RAMP REPORT REGION 2 ADA 2026

Route 7 – Vine Street
Belfast

CR09013

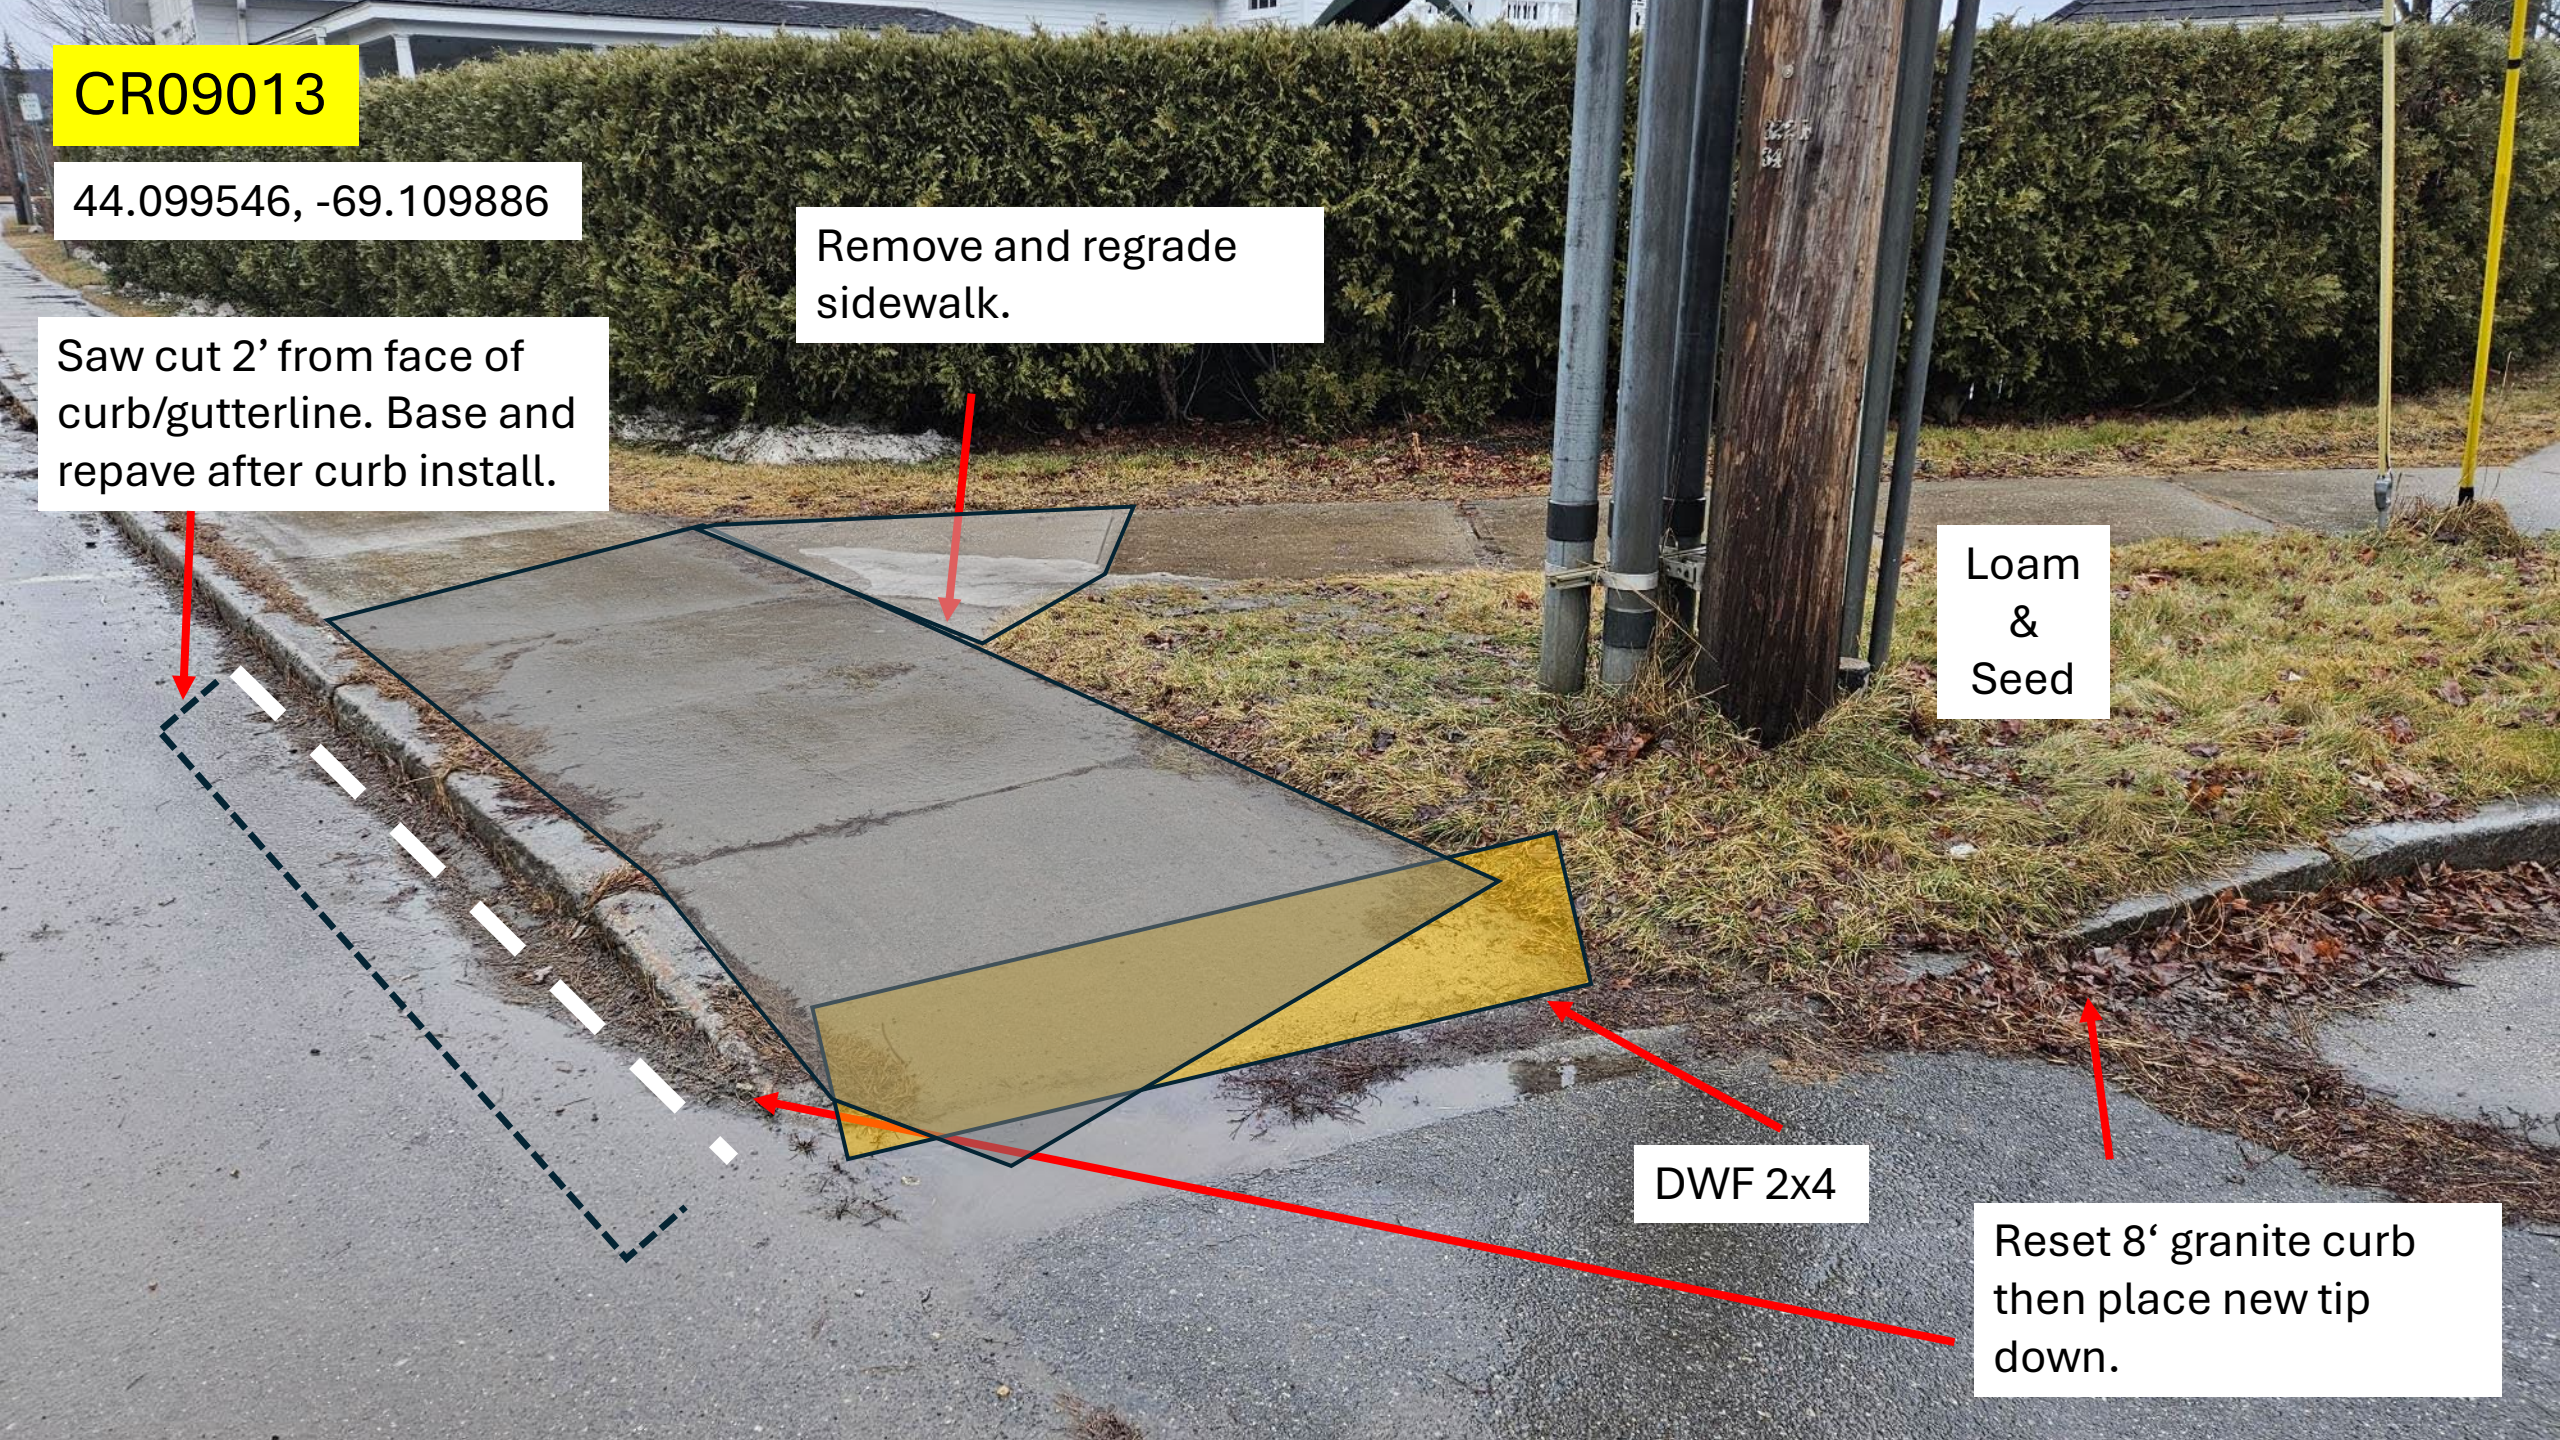
Saw cut 2' from face of curb/gutterline. Base and repave after curb install.

Remove and regrade sidewalk.

Loam
&
Seed

DWF 2x4

Reset 8' granite curb then place new tip down.

CR09015

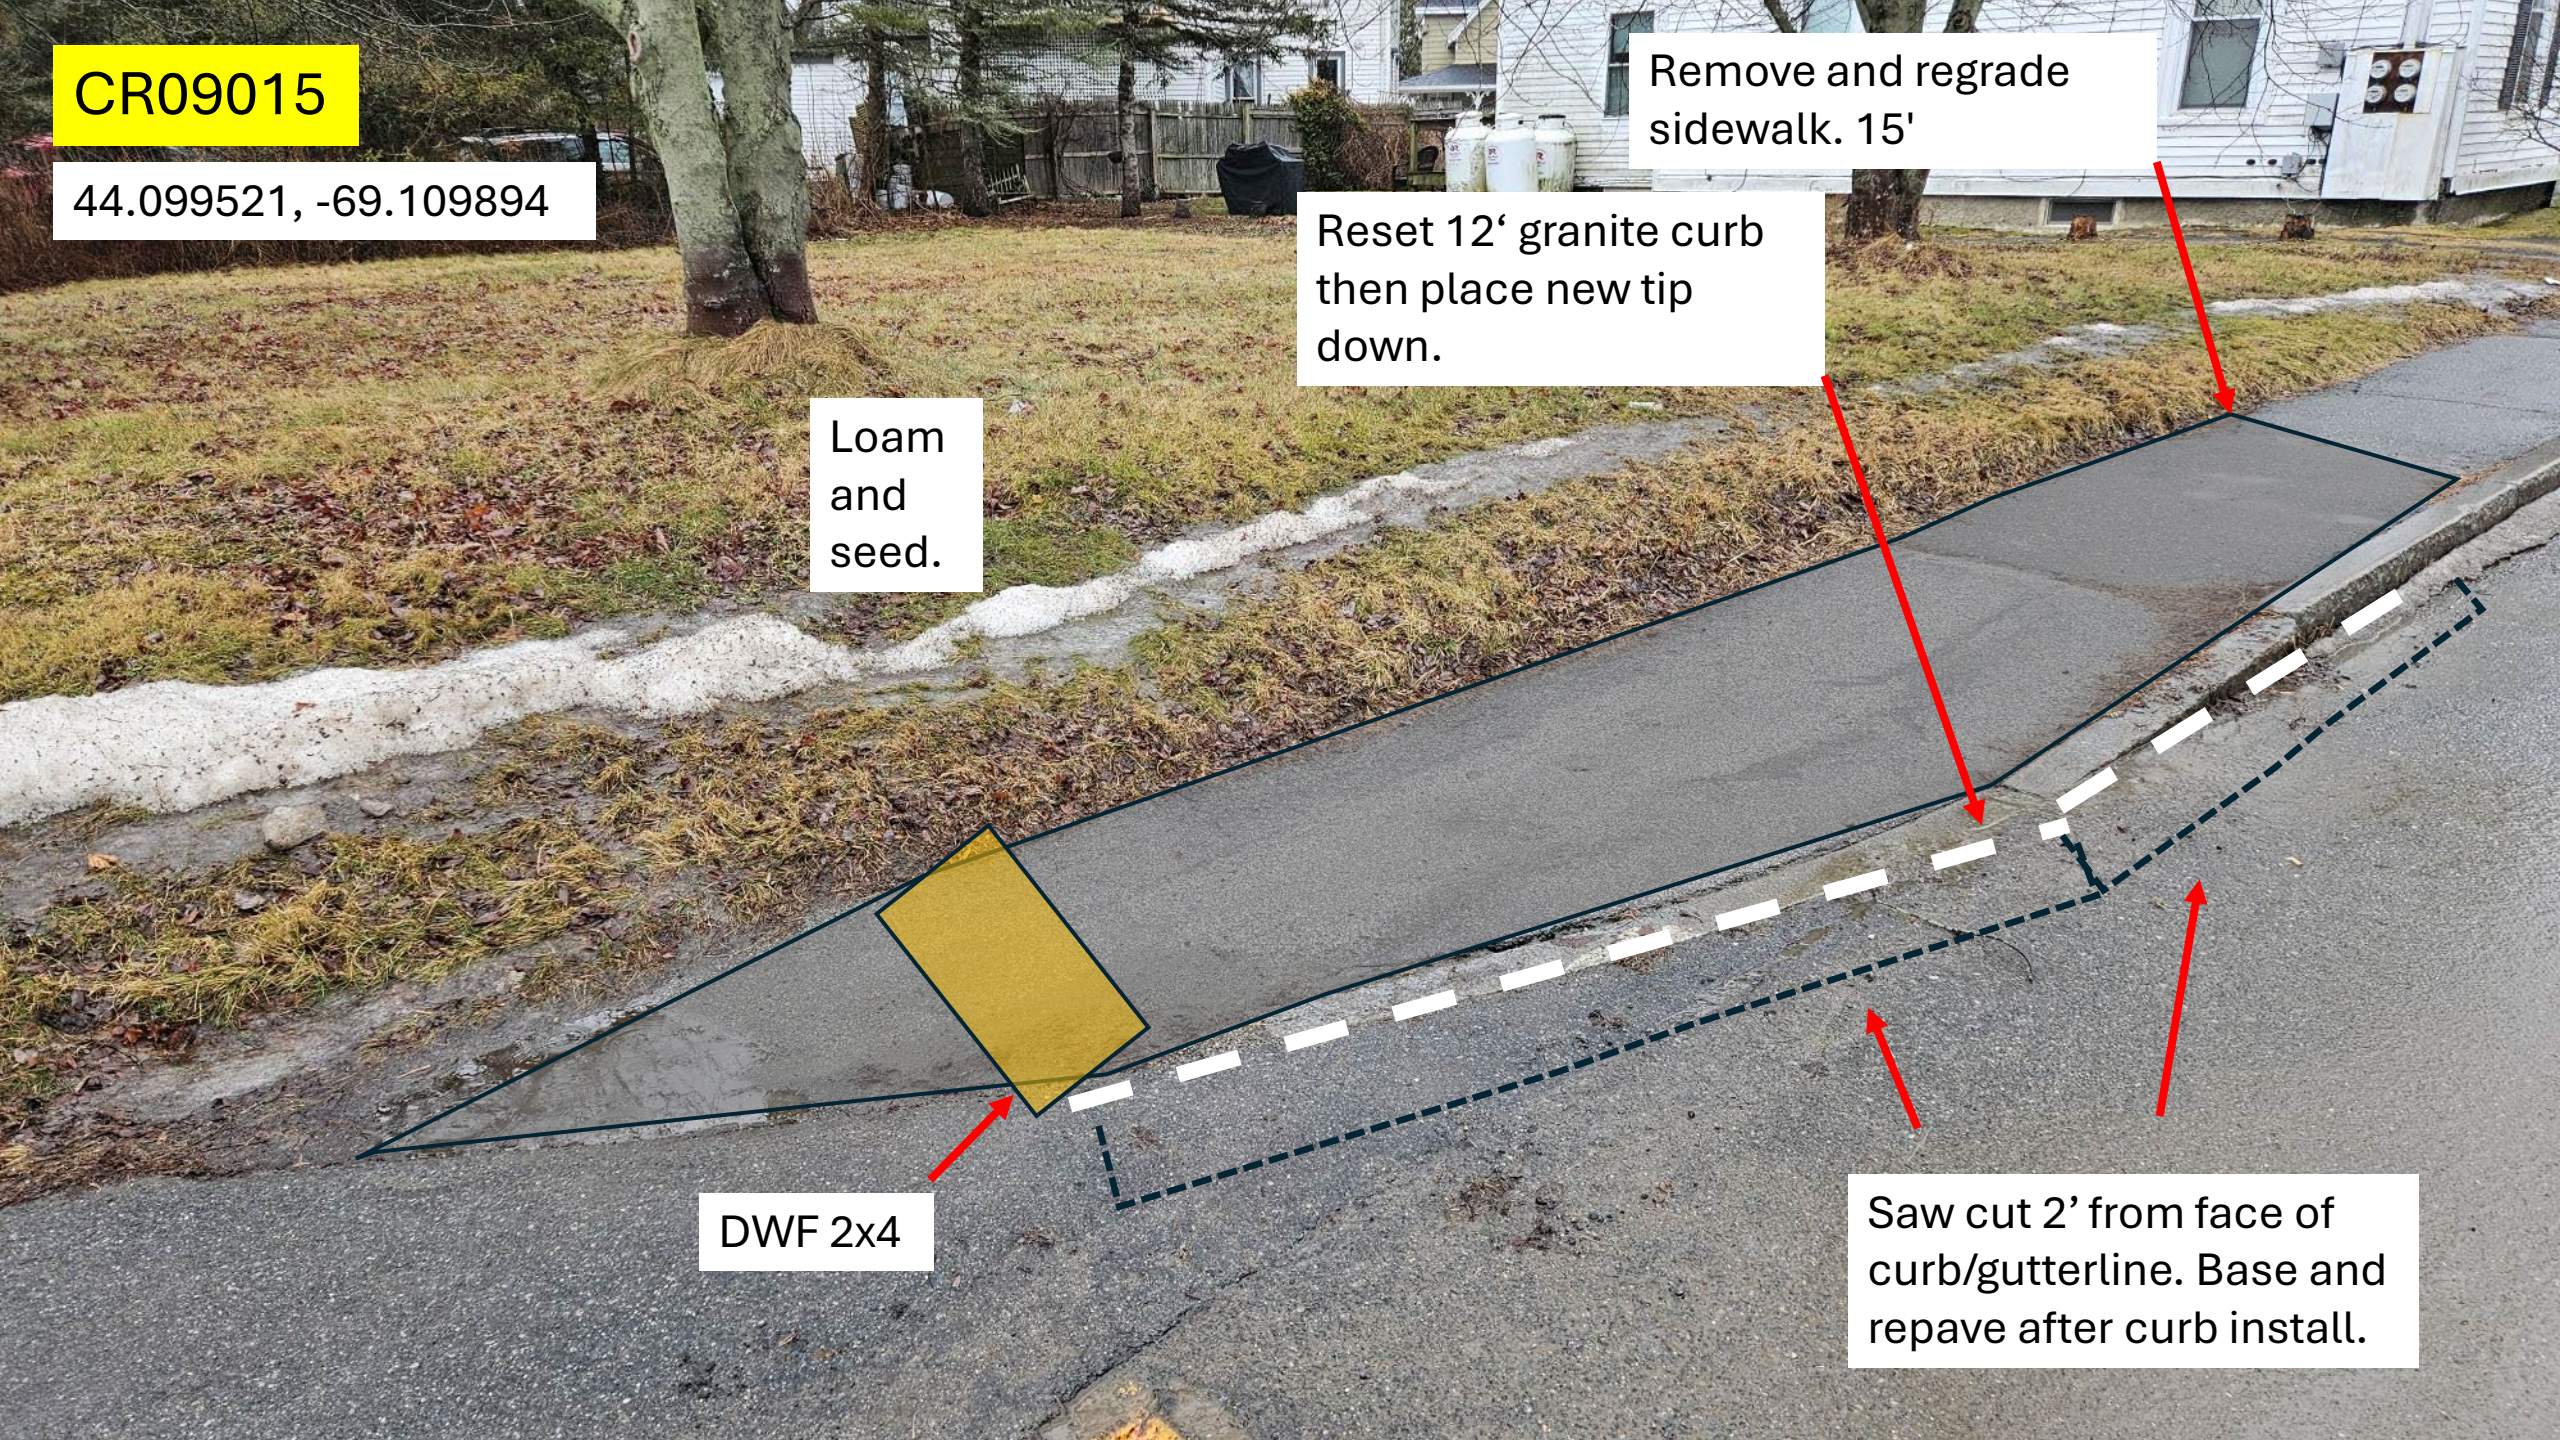
Remove and regrade sidewalk. 15'

Reset 12' granite curb then place new top down.

Loam and seed.

DWF 2x4

Saw cut 2' from face of curb/gutterline. Base and repave after curb install.

CR16815/CR09014

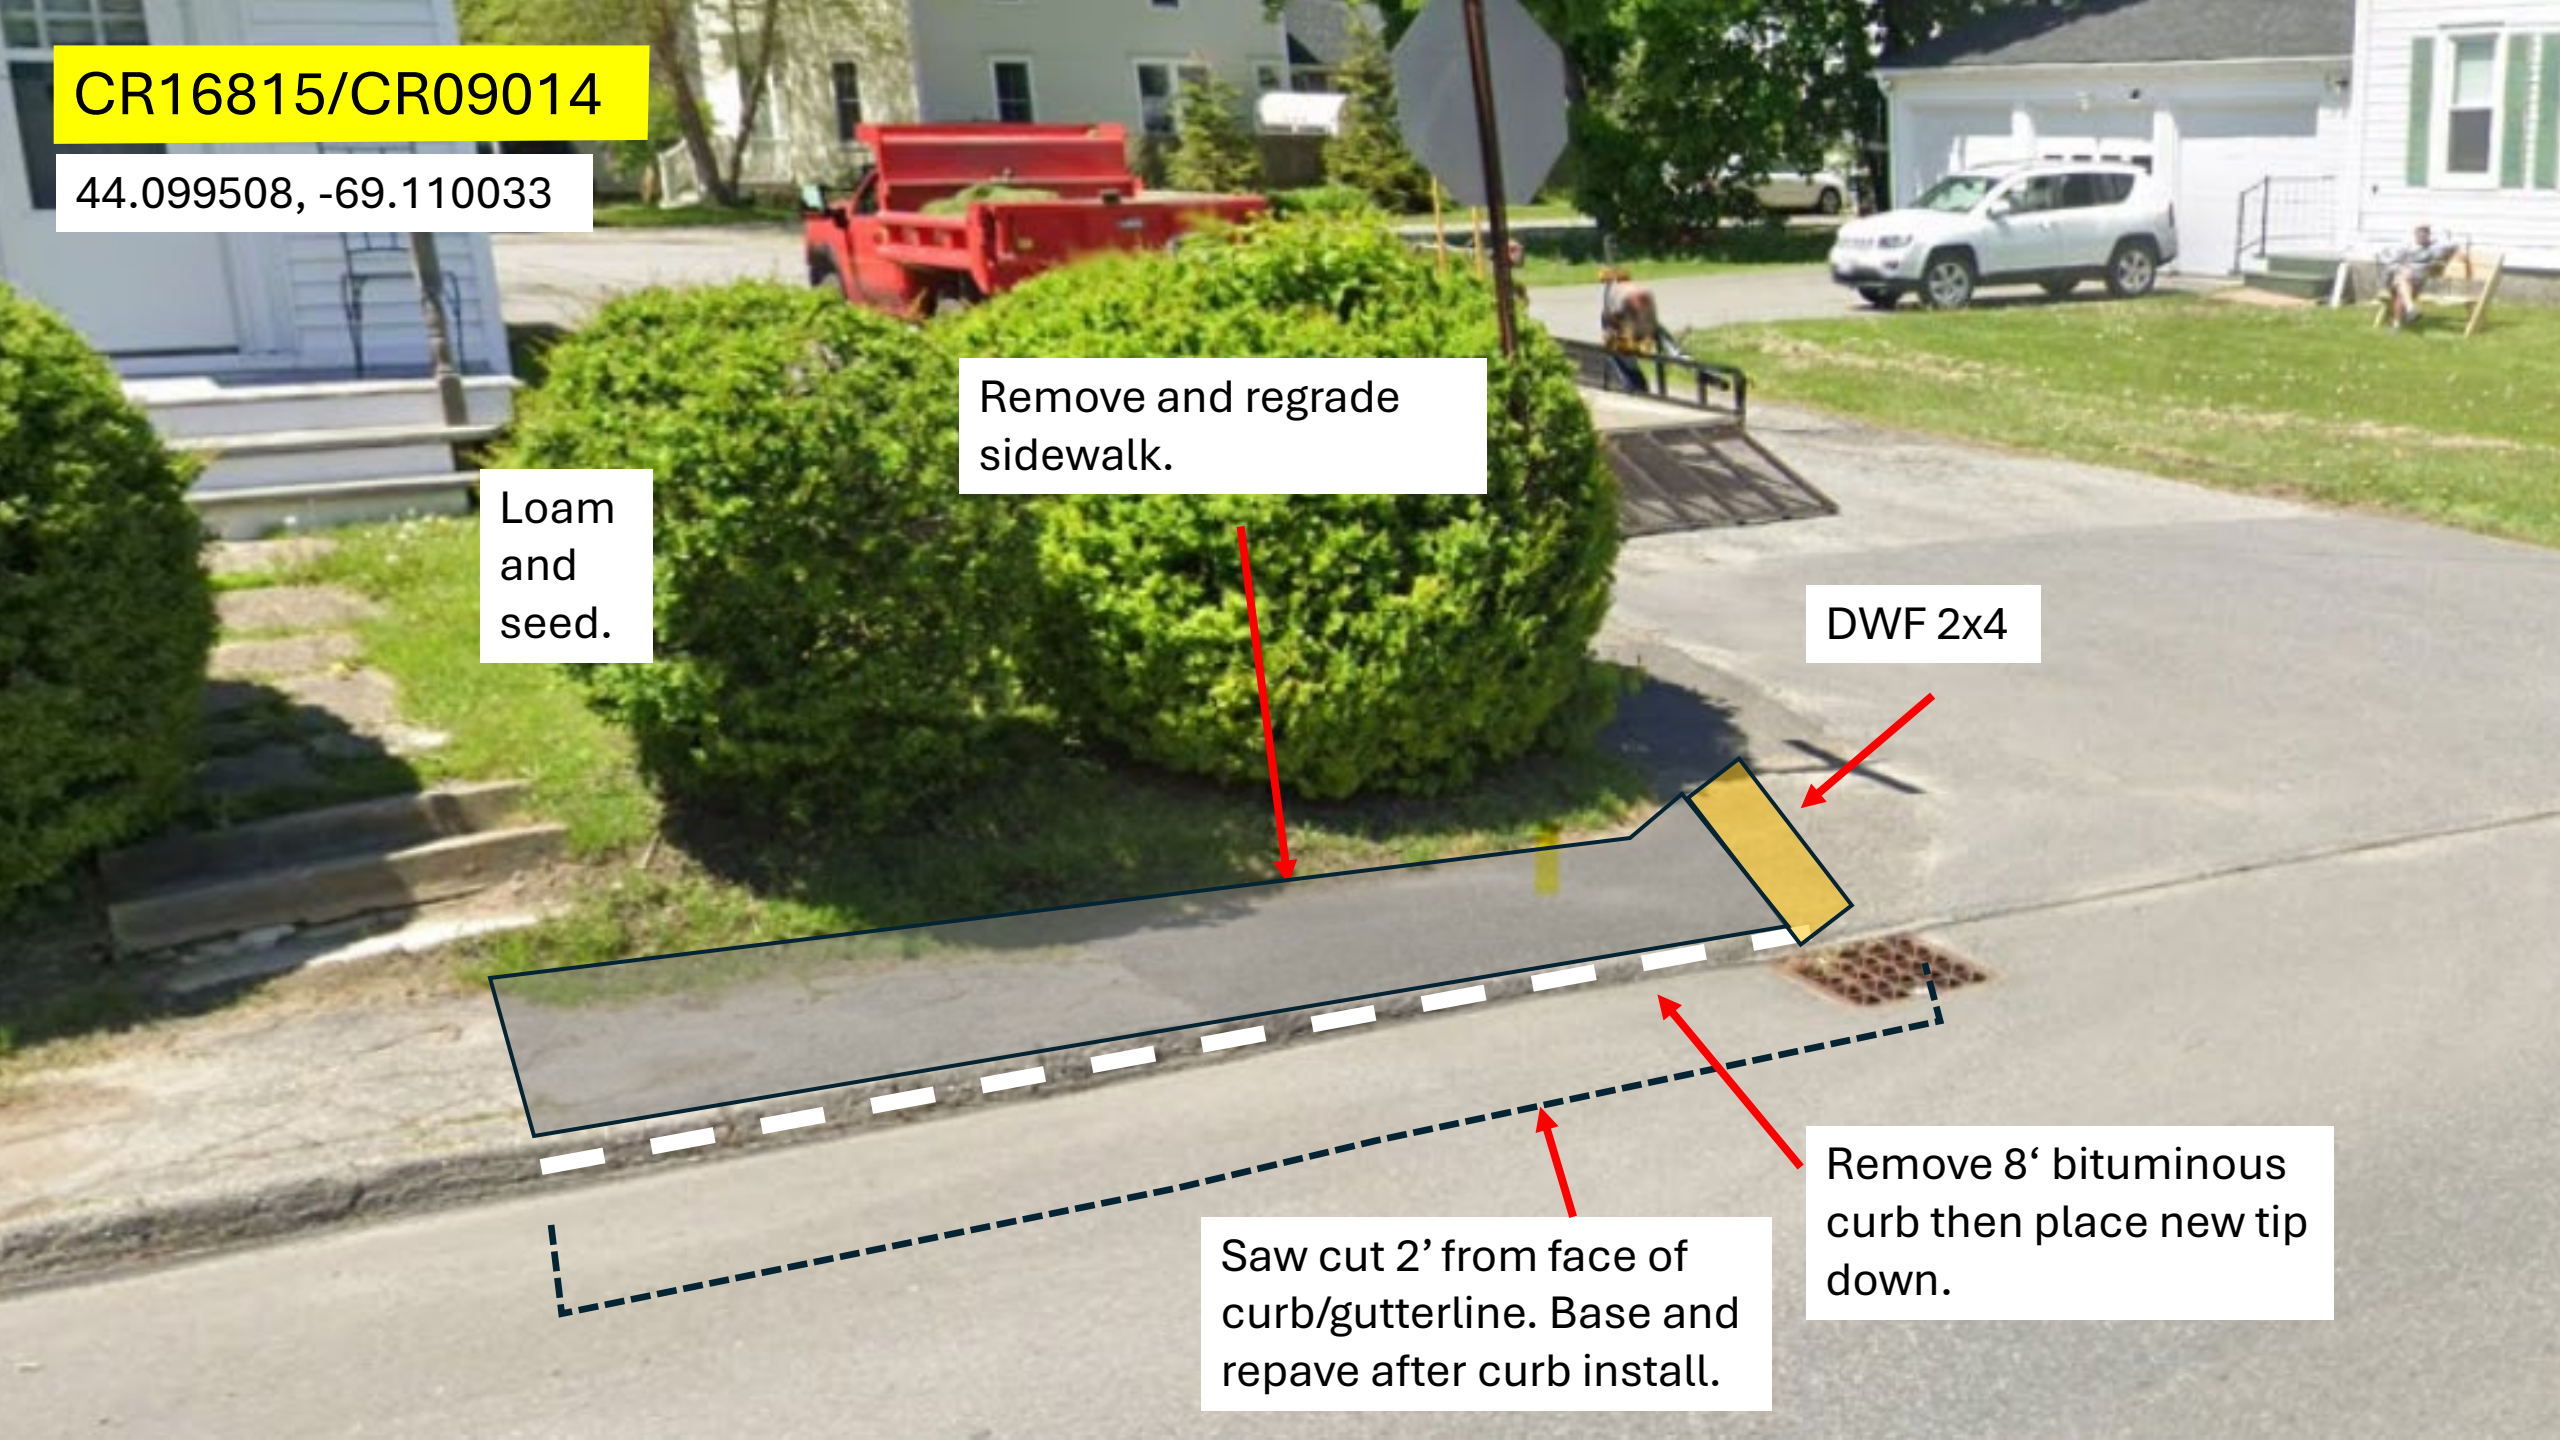
Loam
and
seed.

Remove and regrade
sidewalk.

DWF 2x4

Remove 8' bituminous
curb then place new tip
down.

Saw cut 2' from face of
curb/gutterline. Base and
repave after curb install.
